ōLiv 50TH RESIDENCE
Seattle, Washington

GGLO
CORE Spaces
Recommendation Meeting 01
Meeting Date: Oct 23,2023

Site B - Mid-rise
SDCI Project Number : 3039651-LU
3039717-EG

Proposed sprinkler room location.

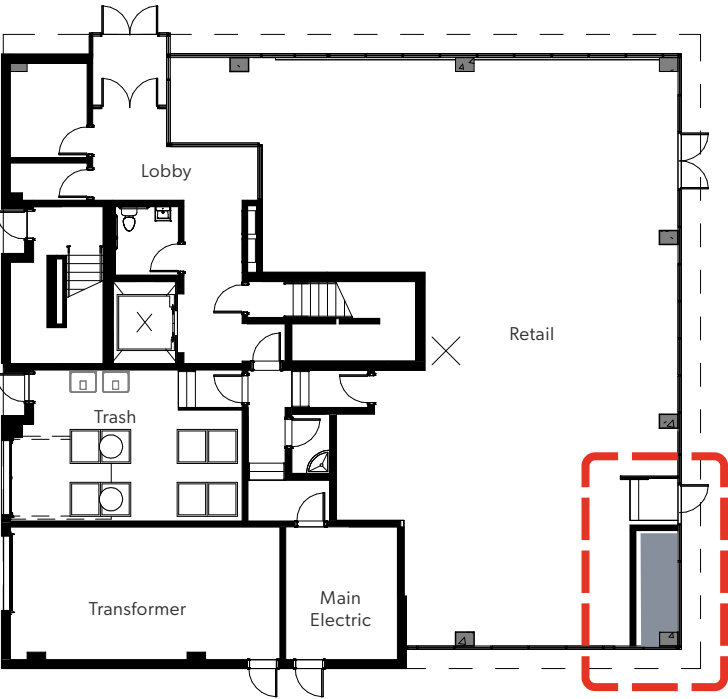
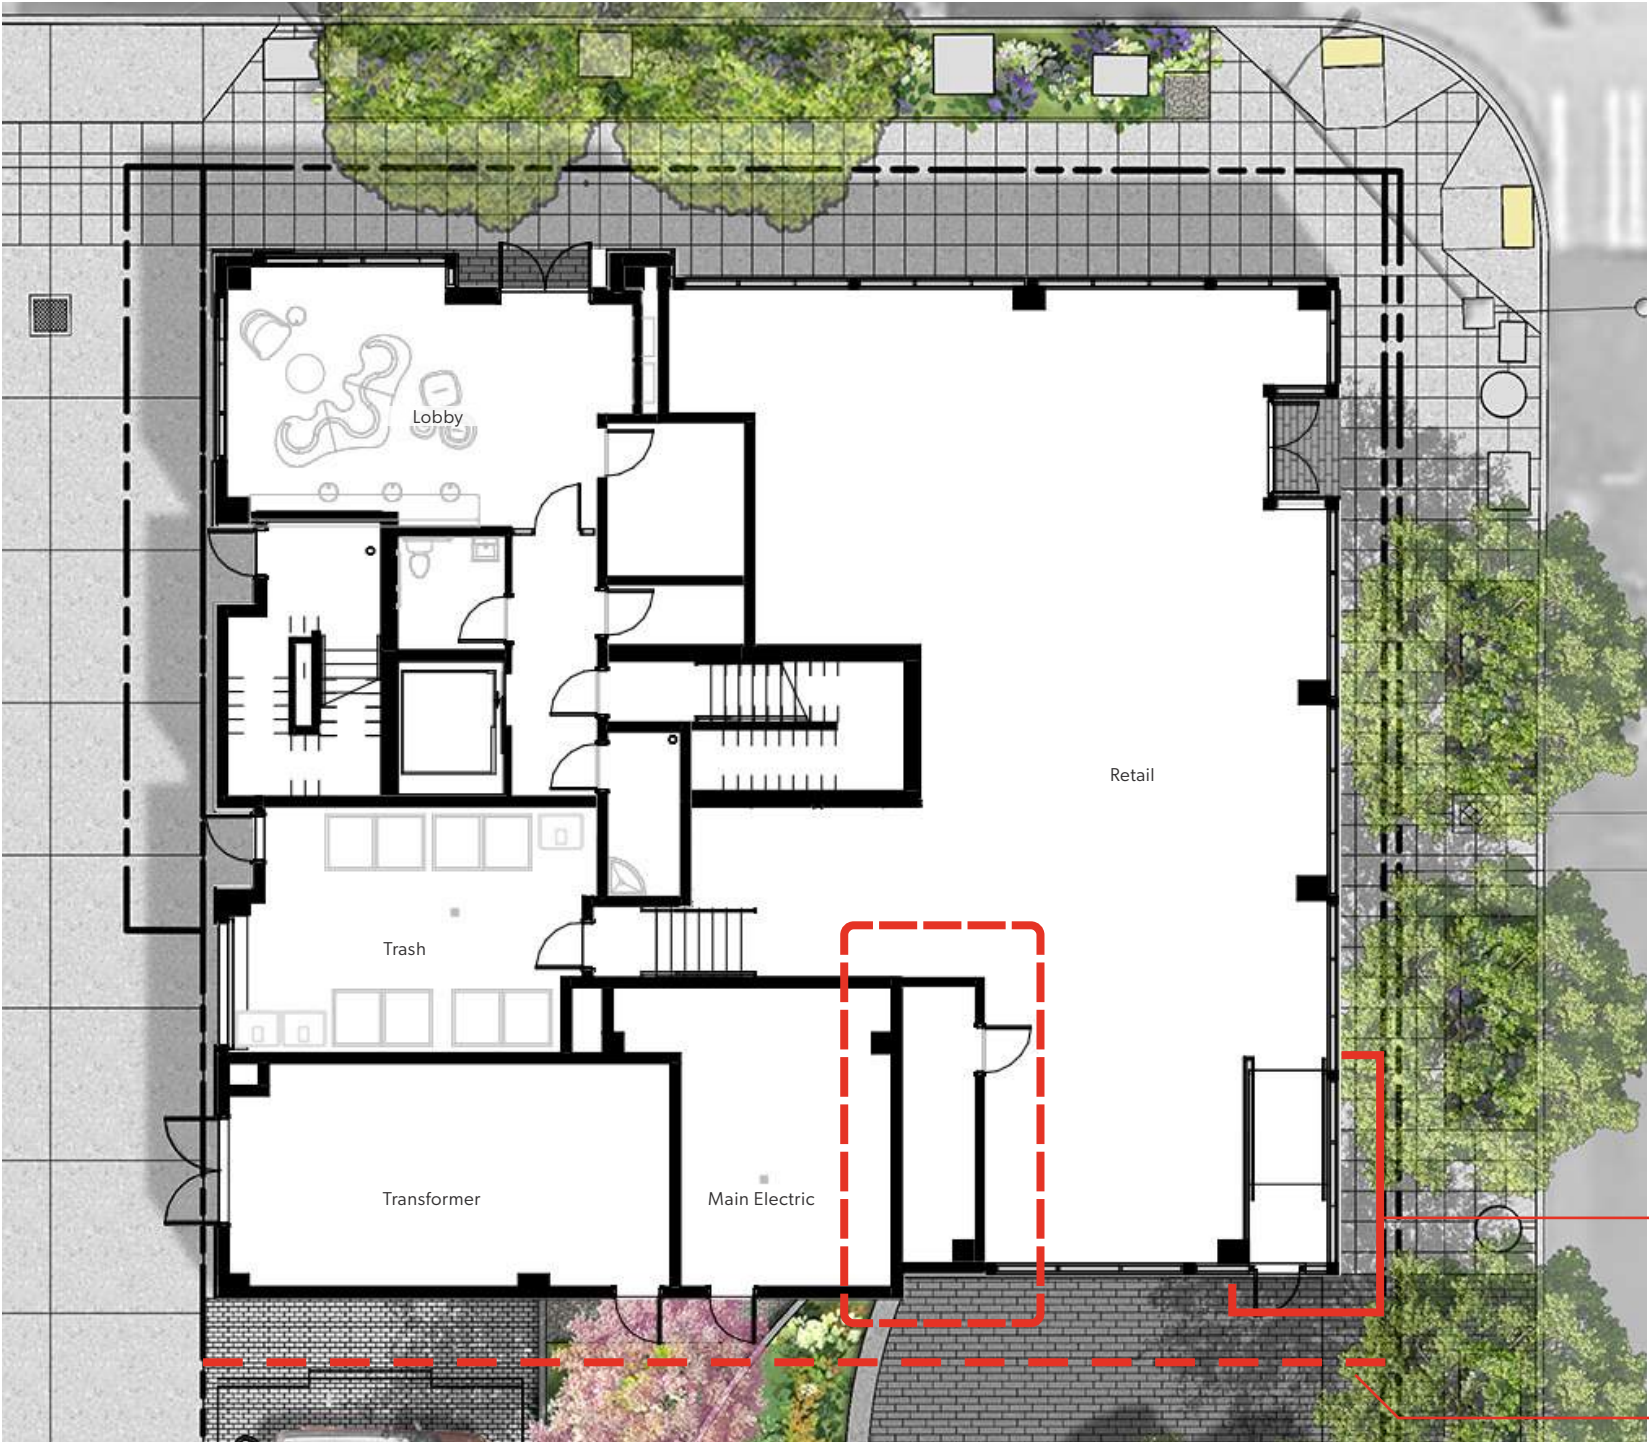
D - The Board requested further information regarding the utility shown at the southeast corner of the ground floor plans. The applicant noted that there is a required fire connection to the water line on Brooklyn Ave that will need to be integrated into the plans. The Board commented that the visual impact of the utility at this very visible corner should be reduced as much as possible.

The sprinkler riser room has been moved inboard. Water connection will be routed to sprinkler riser room underground via the recessed southern glass facade.

View looking South down the alley illustrating storefront window datum shared by the tower retail and midrise lobby.

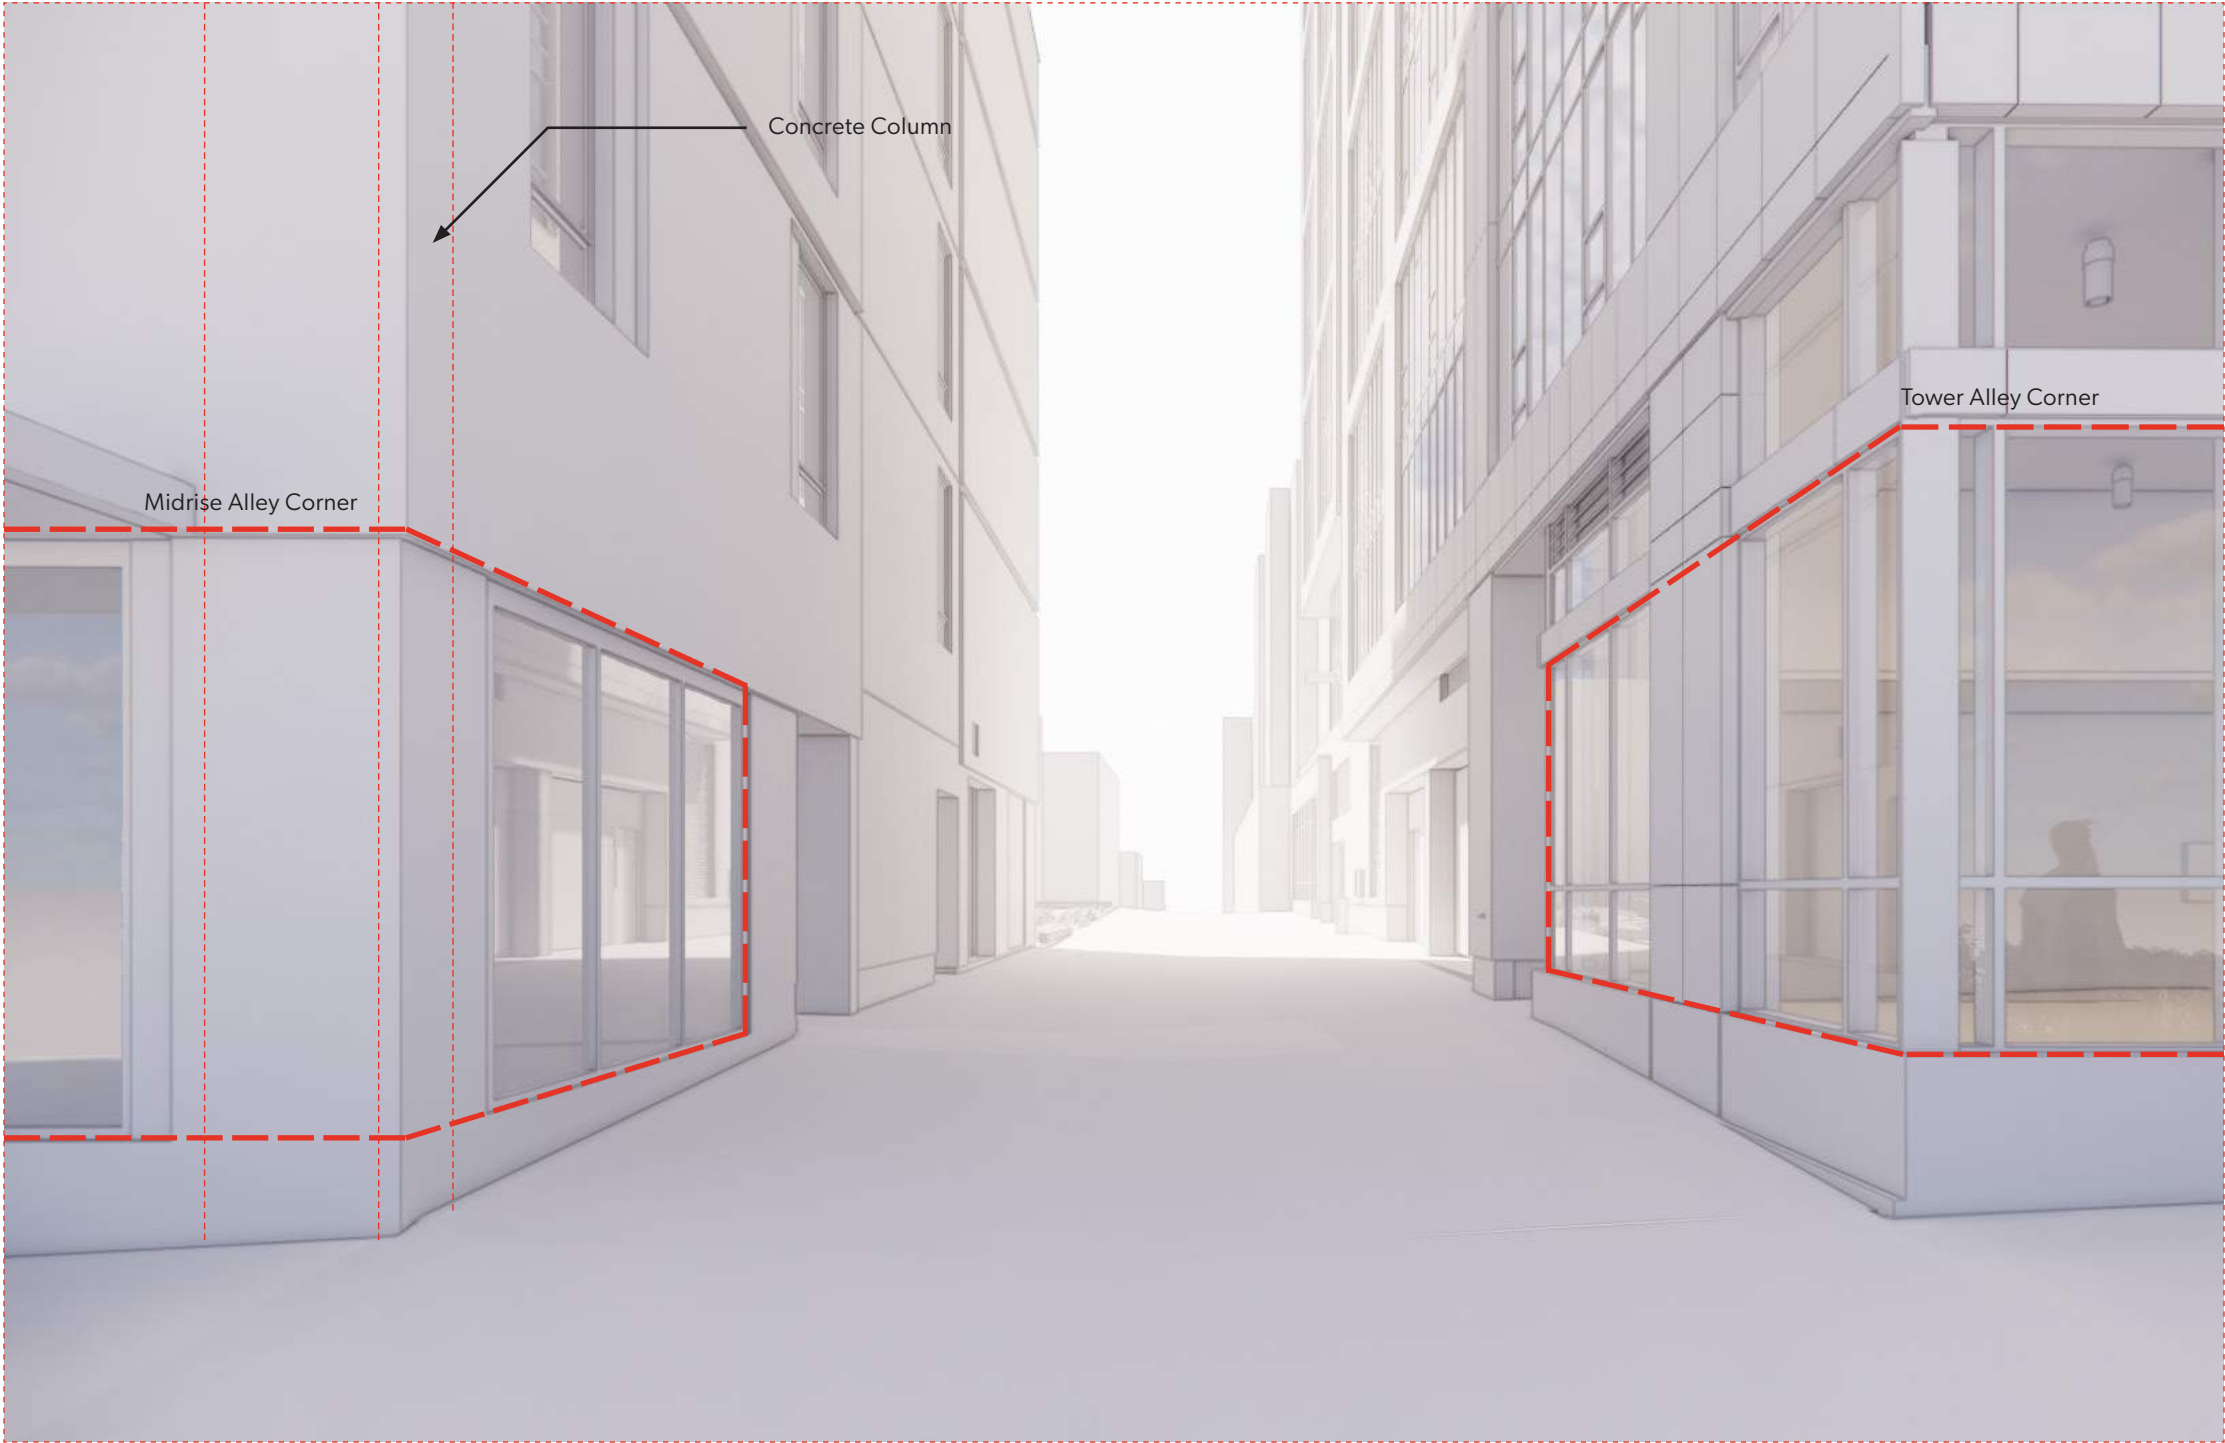
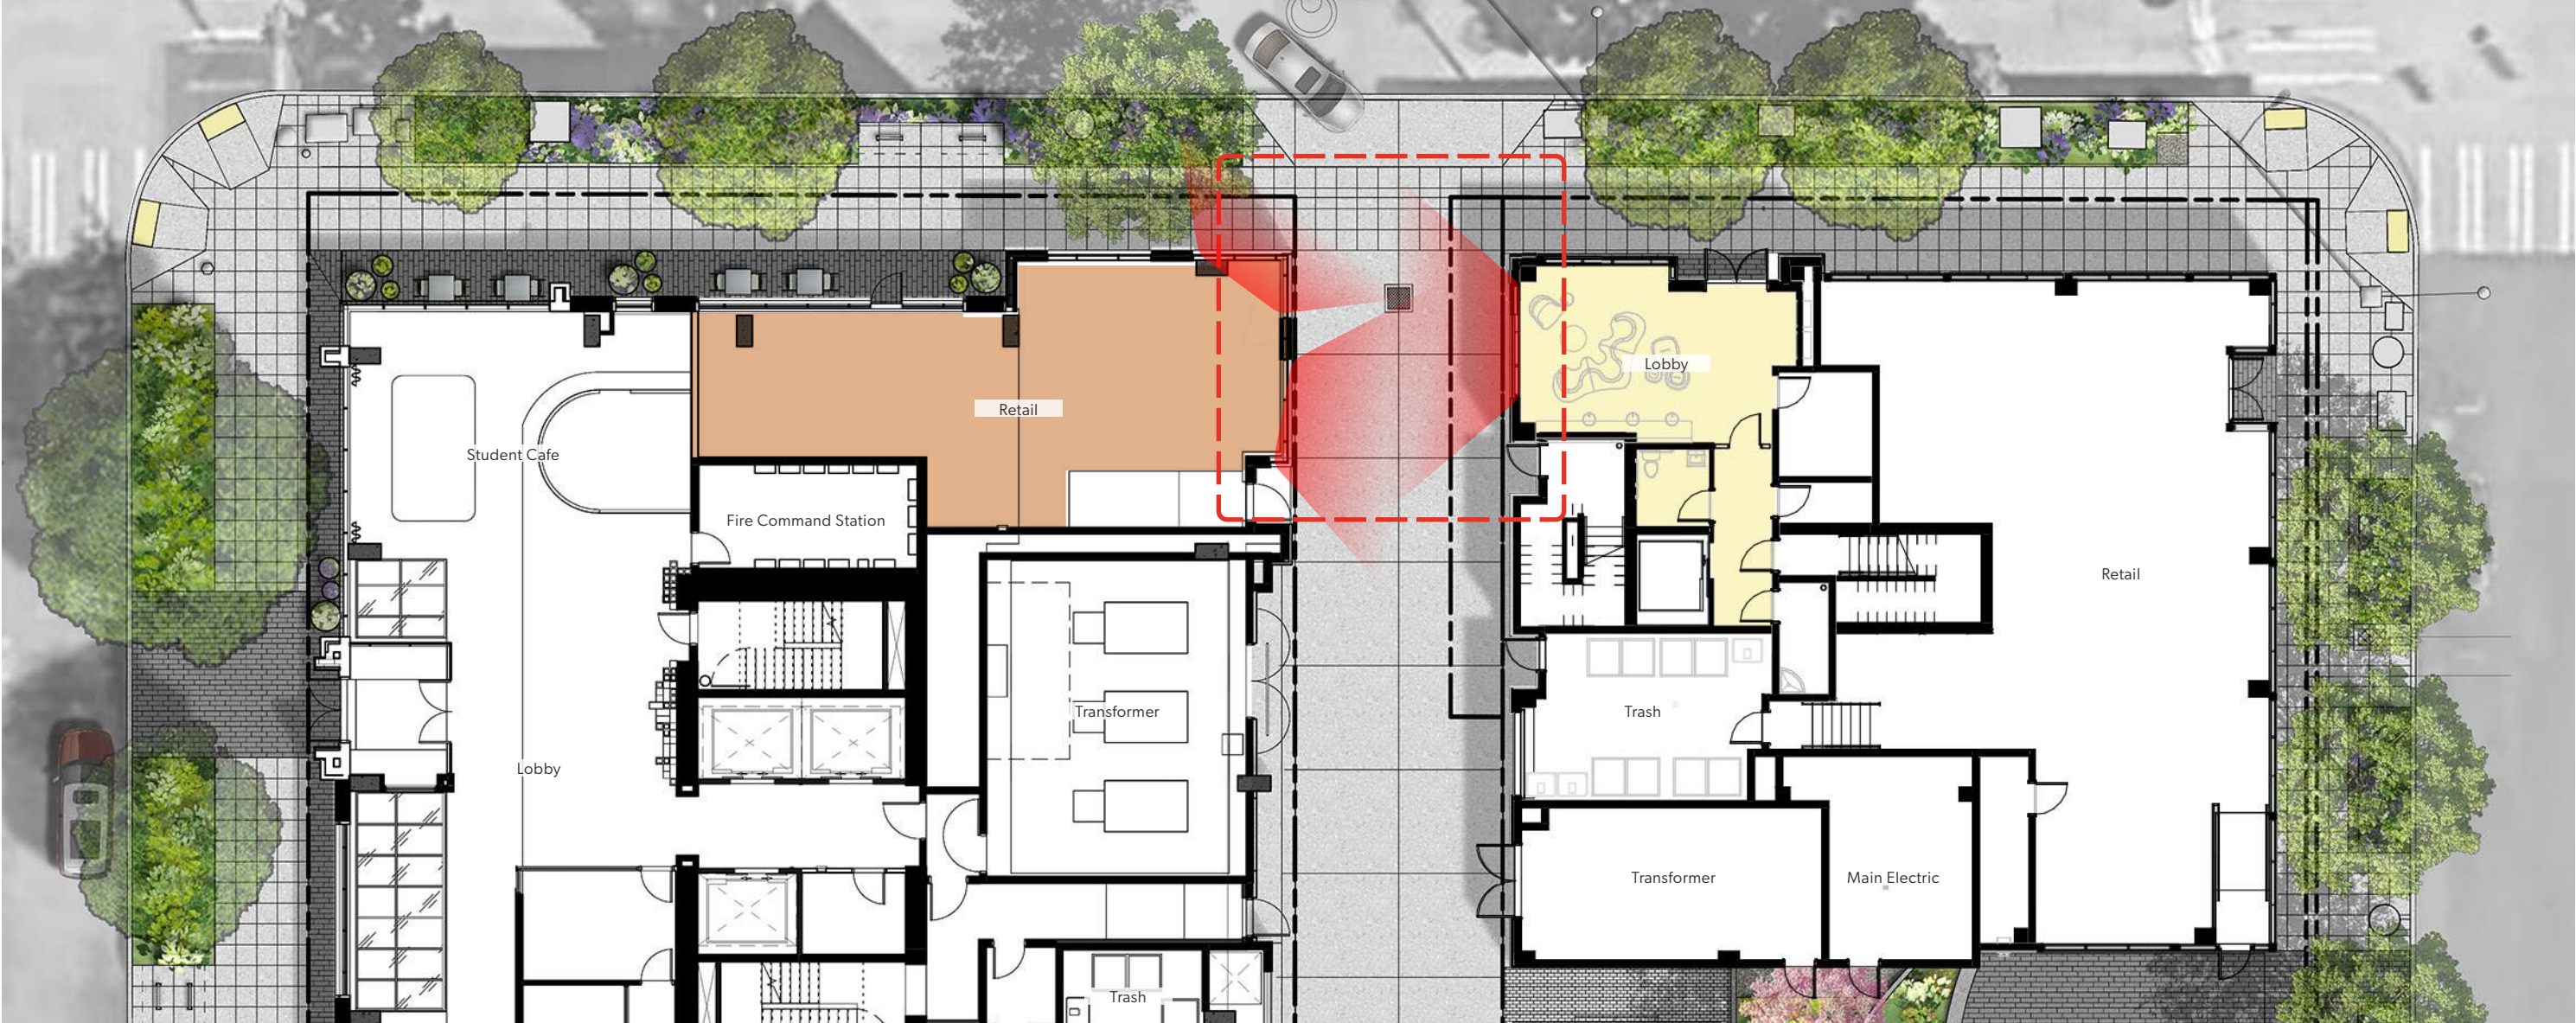
E - Although they supported the location of utilities at the alley, the Board questioned the level of activation of the alley given the amount of blank facades. The Board agreed that the glazing at the northwest corner that wraps into the alley is a strong design move to activate the alley streetscape, especially against the glazing the wraps the adjacent building’s proposed commercial space across the alley. The Board noted that the project should retain the extent of the return of glazing from the corner along the west facade as the design moves forward. The Board requested that street-level views of the project from the northwest be included in the Recommendation packet so that the Board can assess how the alley façade of this building coordinates with the alley façade of the related building to the west.

Residential entry lobby is flanked by glazing on both the street and alley side to maintain a high degree of transparency. Residential entry NW corner grounds to maintain the overall massing move presented at EDG and to mask necessary structural elements.

The program adjacencies of the midrise lobby and tower retail space to the alley, as well as window transparency provide eyes on the alley and illumination.

Midrise and Tower Material Language Comparison

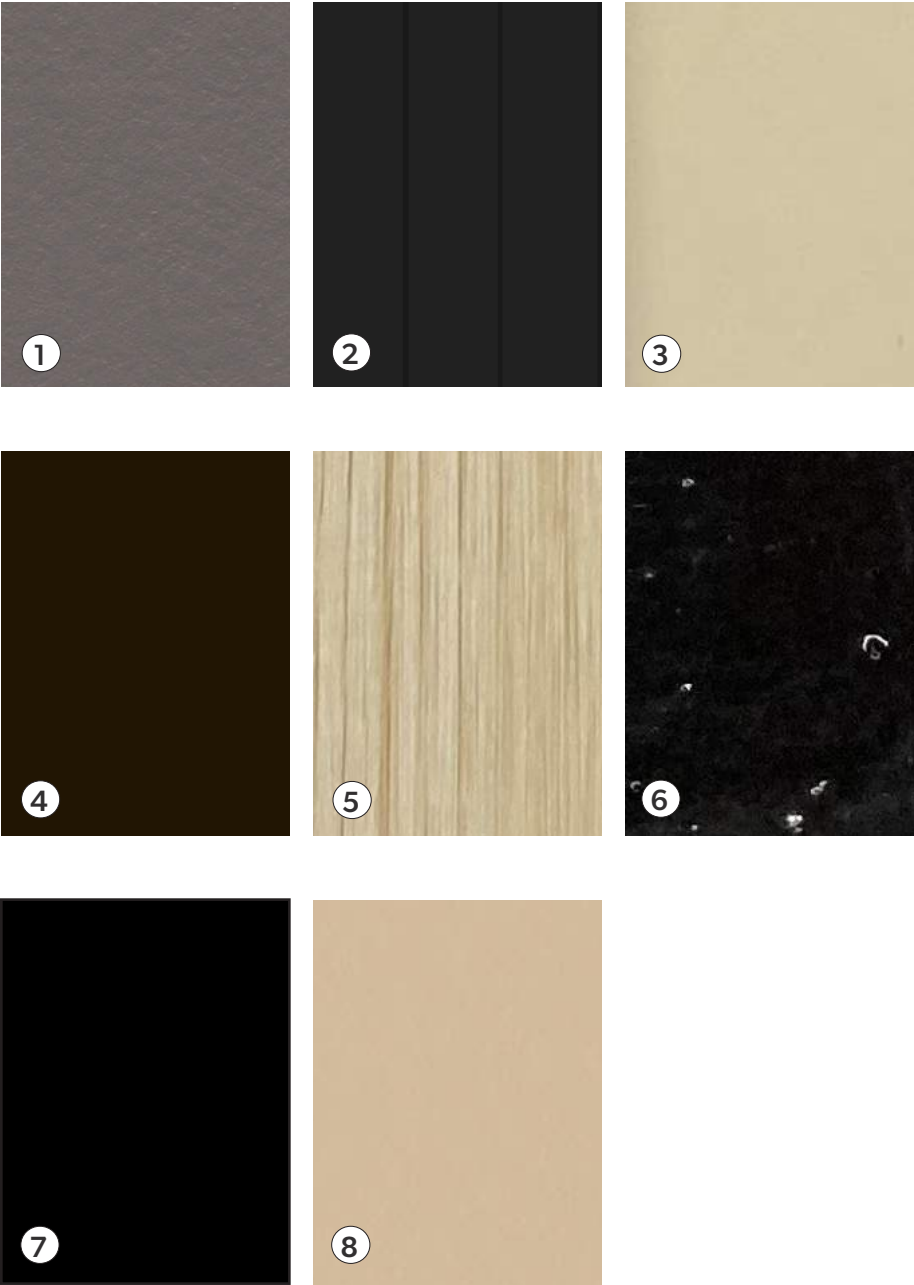
A - The Board asked how the material application of the mid-rise was planned to relate to the material design of the high-rise tower across the alley. The applicant commented that they did not intend to mimic the design of the high-rise building in this mid-rise structure. Although the Board generally agreed with this approach, they noted that there should be some relationship, which may include secondary elements, color, materials selection, artwork, etc. They requested studies at the Recommendation phase to demonstrate how this relationship has been established.

Midrise building takes cues from the design and material language of the adjacent tower.

Dark panel look is rendered via charcoal fiber cement panel. Wood toned accents are of the same texture and look as the tower. Large vinyl windows take the place of the continuous window wall system found in the tower.

The mid-rise storefront emulates the tower materially to maintain visual cohesion at the street level
